BEXLEY LANE SUBDIVISION

APPLICATION NUMBER 7 DATE September 6, 2012
APPLICANT Bexley Lane Subdivision
REQUEST Subdivision

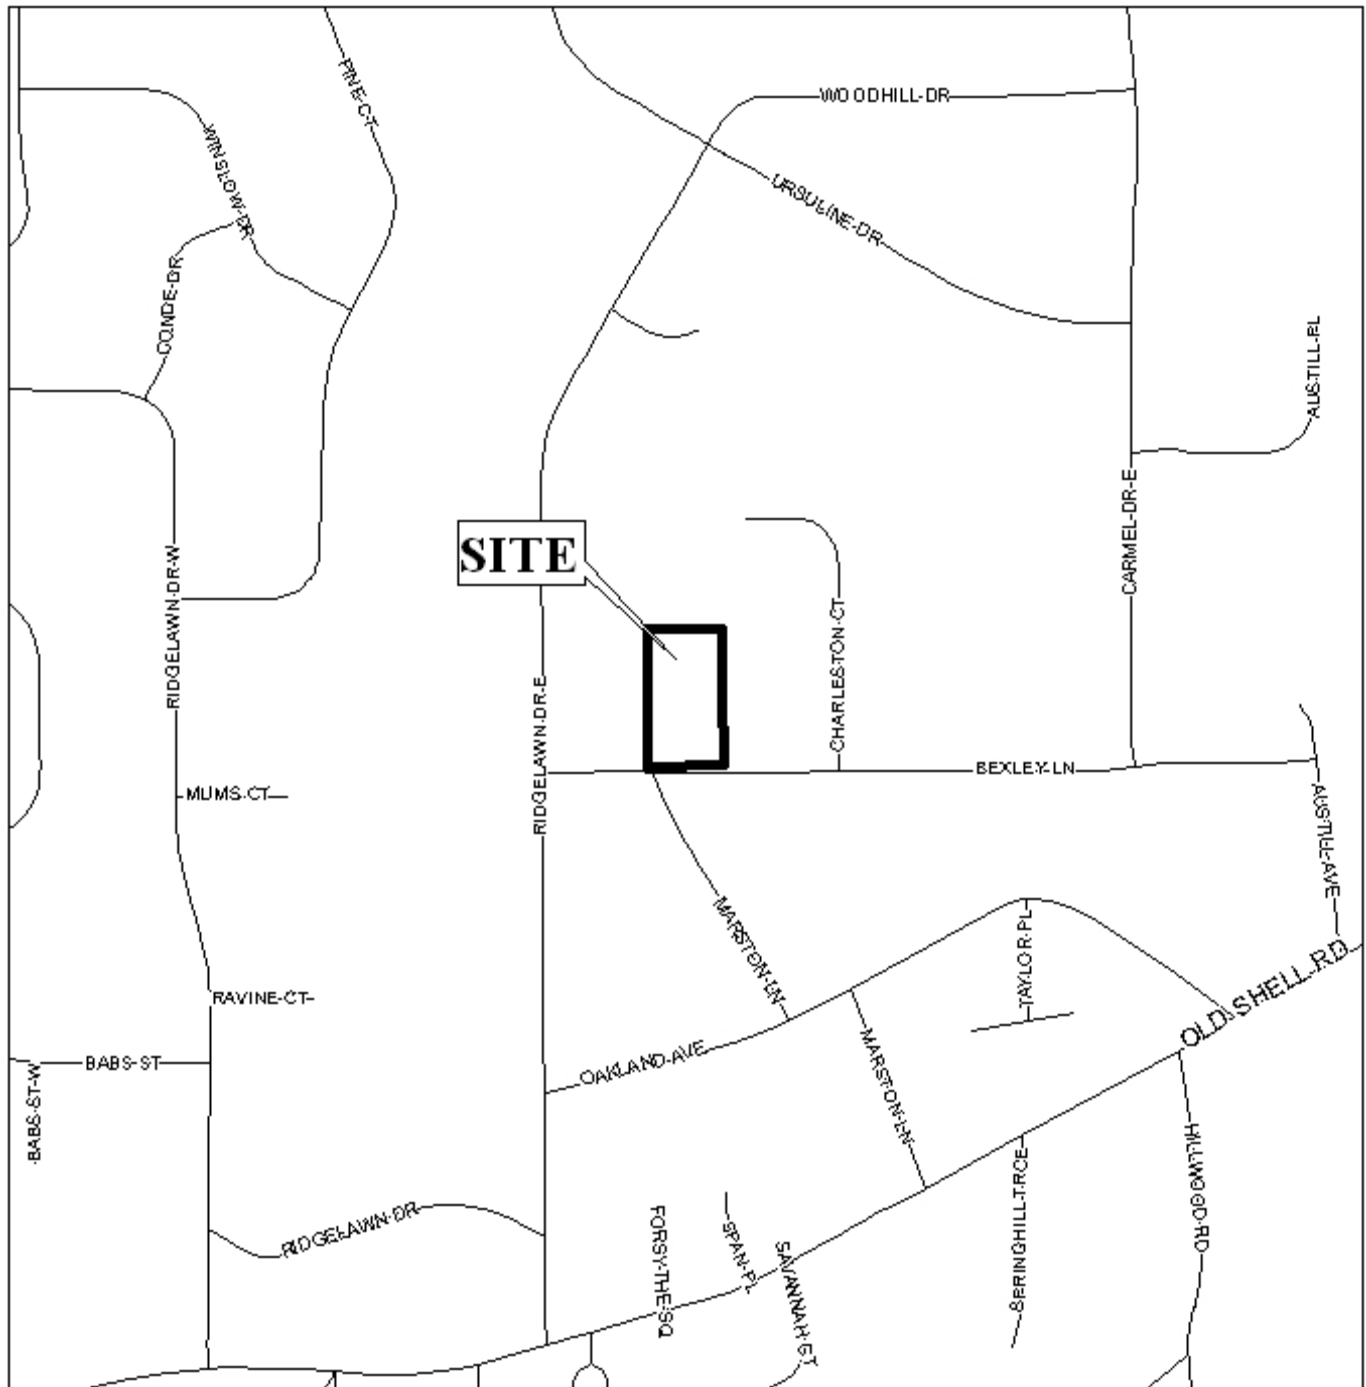
The site fronts onto Bexley Lane, a minor street without curb and gutter, which is illustrated on the preliminary plat to have a right-of-way that varies. According to Section V.B.14. of the Subdivision Regulations, streets without curb and gutter should have a right-of-way width of 60 feet. The preliminary plat shows frontage proposed to be dedicated to the City of Mobile that would provide 25' from the centerline, however dedication to provide 30' from the centerline should be required.

The 25-foot minimum building setback line, required in Section V.D.9., is illustrated and labeled on the preliminary plat. If approved, the 25-foot building setback line should be retained on the Final Plat.

As a means of access management, a note should be placed on the Final Plat, if approved, stating that Lot 1 is limited to one curb cut to Bexley Lane, with the size, location and design to be approved by Traffic Engineering and conform to AASHTO standards.

It should be noted that the preliminary plat illustrates a shed on the proposed lot that is 2.4' from the side property line. If approved, documentation should be submitted that the shed has been relocated to 8' from the side property line or a demolition permit should be obtained to remove the structure.

- 1) dedication to provide 30' from the centerline as on the preliminary plat;
- 2) illustration of the 25' minimum building setback line along Bexley Lane adjusted to be measured from required dedication;

- 3) retention of the lot size in square feet and acres;
- 4) provision of documentation that the shed has been relocated to 8' from the side property line or obtaining of a demolition permit;

- 7) placement of a note on the Final Plat limiting Lot 1 to one curb cut to Bexley Lane, with the size, design, and location to be approved by Traffic Engineering and conform to AASHTO standards;
